MEMORANDUM

RE: Appeal of Denial of Request for an Exception to allow an existing approach on 5th Street to be utilized for ingress and egress to a commercial parcel.
Lot 5, North 80 Subdivision, Section 19, T1N, R8E, BHM, Rapid City, Pennington County, South Dakota.

REQUEST FOR EXCEPTION RAPID CITY DESIGN STANDARD / CRITERIA / REGULATIONS

Proposed Master Layout Plan
Lot 5 of North 80 Subdivision
Rapid City,
Pennington County, South Dakota

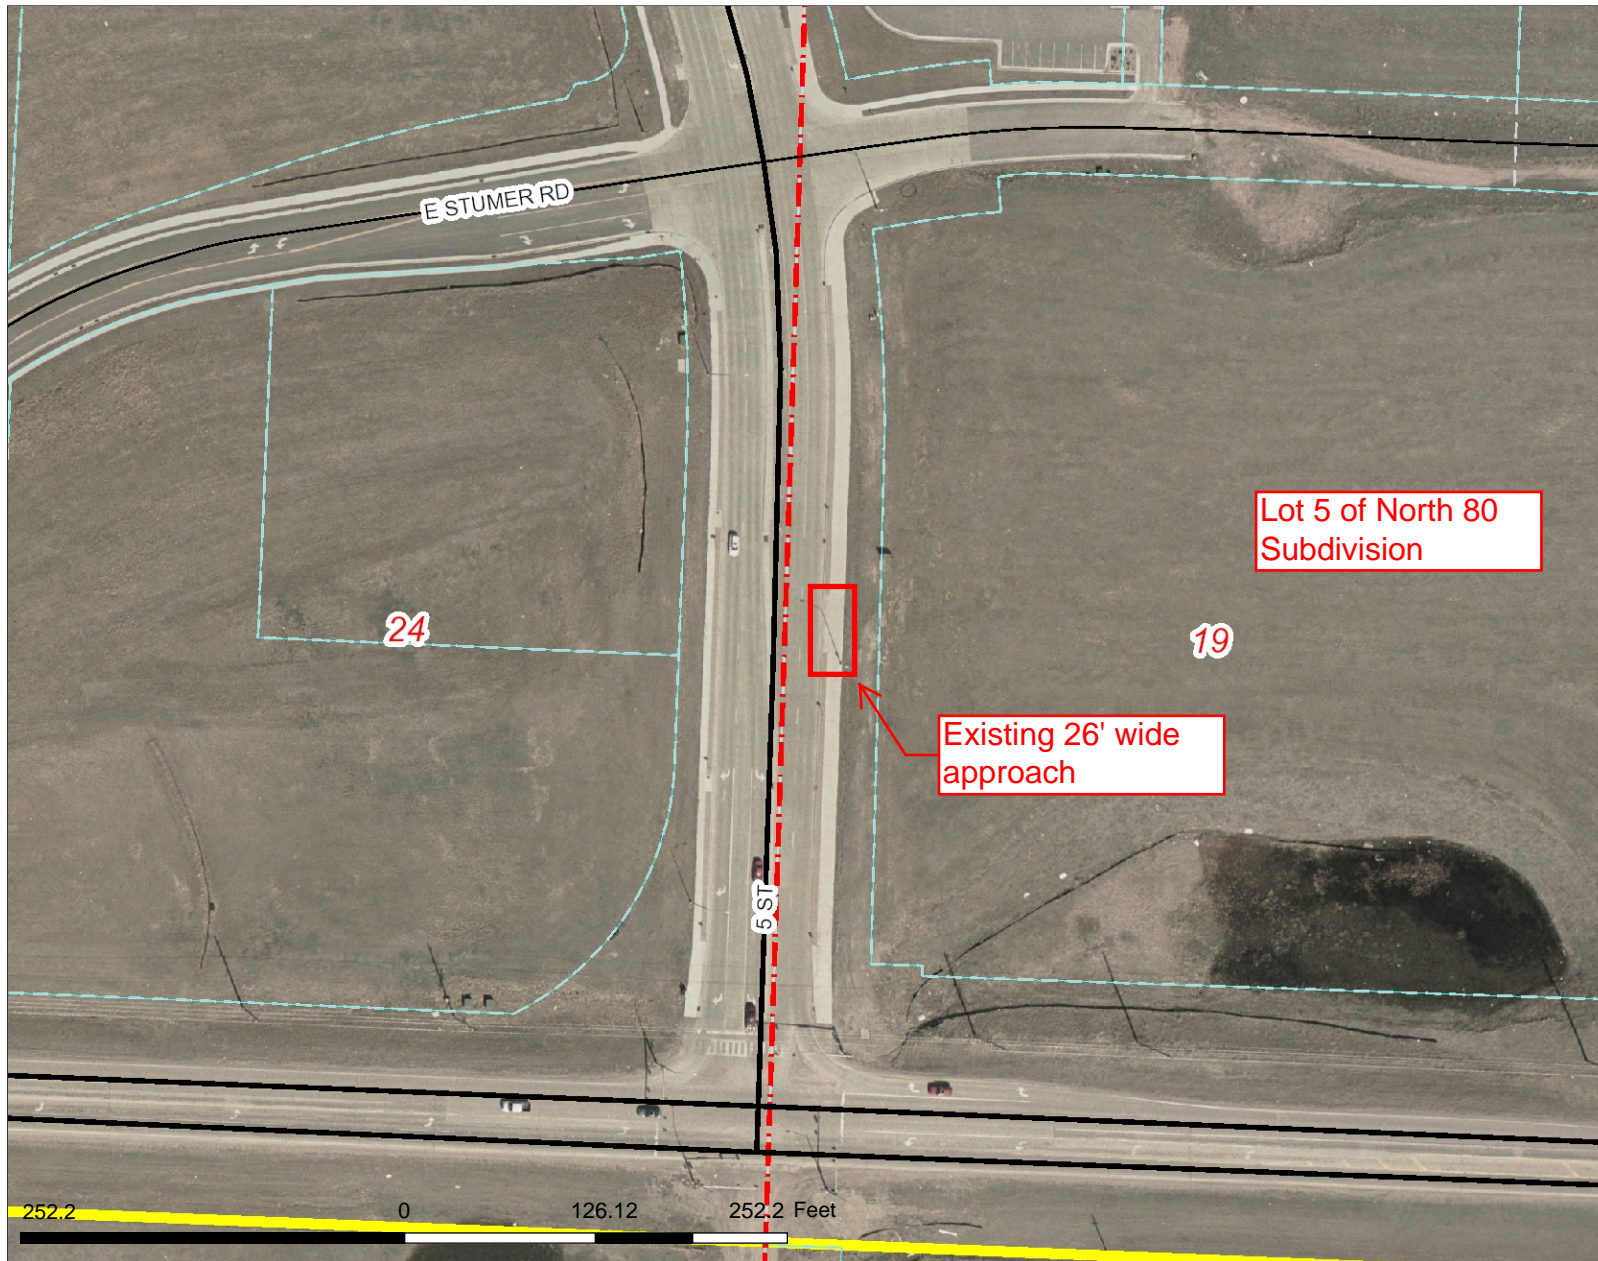
the platting process of Lot 5 of North 80 Subdivision. The preliminary master plan submitted with this exception request does show the approach being used for access to a single commercial business, however, the potential for through traffic to the development east and north of the business is created. All previously submitted master plans for Lot 5 indicated that access would be taken from East Stumer Road. At the time of platting, the Rapid City Street Design Criteria Manual was in effect which established in Section 8.2.1.I, *If a property has frontage on more than one street, access will be permitted only on the less traveled street frontage where standards can be meet.* Per this criteria, Lot 5 shall take access from East Stumer Road. The Rapid City Infrastructure Design Criteria Manual, which is has replaced the Street Design Criteria Manual, does not contain the same criteria. However, Staff still believes that access from the less traveled street (East Stumer Road) is the safest access to Lot 5.

Per the RC IDCM Section 2.1b.1 no access approach shall be located so as to create a hazard or as to invite unsafe vehicular movements. Staff has concerns that traffic movements in/out of the approach would create unsafe movements. Also, AASHTO recommends against locating driveways in the functional area of an intersection. The approach is located in the functional area of the 5th St + E. Stumer Rd intersection.

Existing Approach
to be utilized as
"RIGHT IN
RIGHT OUT
ONLY"

Staff Recommendation: Staff recommends denial of the request to allow an existing approach on 5th Street to be utilized for ingress and egress to a commercial parcel.
